Access Compliance Report

Public Rights-of-Way

(Curb Ramps)

Intersection ID: 42683	Main Street: RUNNYMEDE_LN	Cross Street: SHARON_RD	Location: SE
ADA ID: 7828178E696D	Ramp Type: Perp	Initial Pass/Fail: Fail	Overall Compliance: No
Severity Score: 13.75			
Codes/Mitigation Info/Possible Solution		Field Measurements/Component Compliance

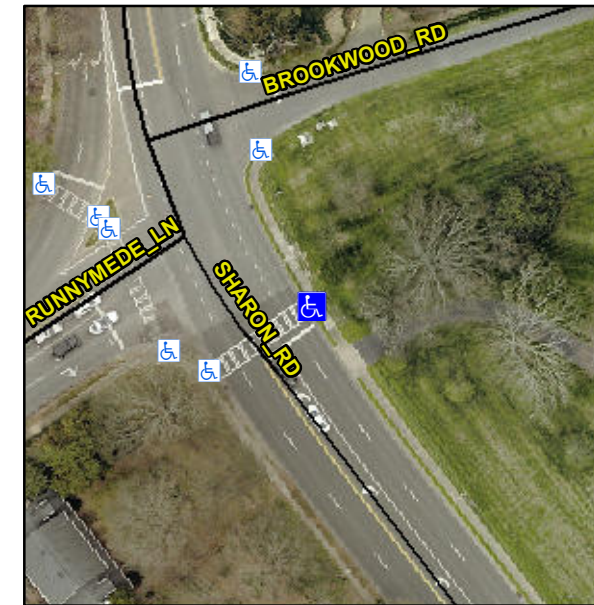
Not Found, R304.2.2, R304.5.3

Compliance	Description	Data	Compliance	Description	Data
N/A	Ramp Length (in)	84.0	No	Ramp Slope (%)	8.8
Yes	Ramp Width (in)	48.0	No	Ramp XSlope (%)	3.7
N/A	Flare Type LT	N/A	N/A	Flare Type RT	N/A
N/A	Flare Slope LT (%)	N/A	N/A	Flare Slope RT (%)	N/A
N/A	Flare Traversable LT?	N/A	N/A	Flare Traversable RT?	N/A
N/A	Landing Length (in)	N/A	N/A	DWS Provided?	N/A
N/A	Landing Width (in)	N/A	N/A	DWS Contrast?	N/A
N/A	Landing Slope (%)	N/A	N/A	DWS Length (in)	N/A
N/A	Landing X Slope (%)	N/A	N/A	DWS Full Width?	N/A
N/A	Landing Curb? (Y/N)	N/A	N/A	DWS Offset (in)	N/A
N/A	Shared Landing?	N/A			
N/A	Gutter Ponding?	N/A	N/A	Gutter Slope (%)	N/A
N/A	Gutter Lip Ht (in)	N/A	N/A	Gutter X Slope (%)	N/A
N/A	Painted X Walk1?	Yes	N/A	Painted X Walk2?	N/A
	X Walk 1 Direction	To W		X Walk 2 Direction	N/A
N/A	X Walk 1 Width (in)	118.0	N/A	X Walk 2 Width (in)	N/A
	X Walk 1 Slope (%)	3.3		X Walk 2 Slope (%)	N/A
	X Walk 1 X Slope (%)	2.2		X Walk 2 X Slope (%)	N/A

Remove & Replace Entire Ramp.
